Planning application PL/2026/02918 Replacement of existing railings and gates

Planning application PL/2026/02918 Lockeridge school railings

Replacement of existing railings

Photos

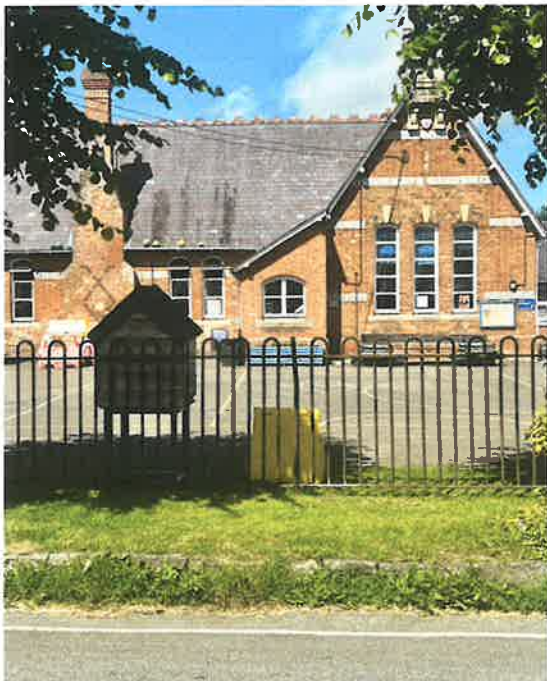
If the application plan is to be approved in principle, I would like to put forward the following idea: **why not raise the existing railings from the base?** They were moved back behind the trees c.25 years ago so the fixings bolts are modern and easily undone.

Top left: Proposed height would be level with ridge of wooden box (note sarsen kerbstones)

Top right: Comparison old and new railing types

Bottom: Easily removed modern bolts
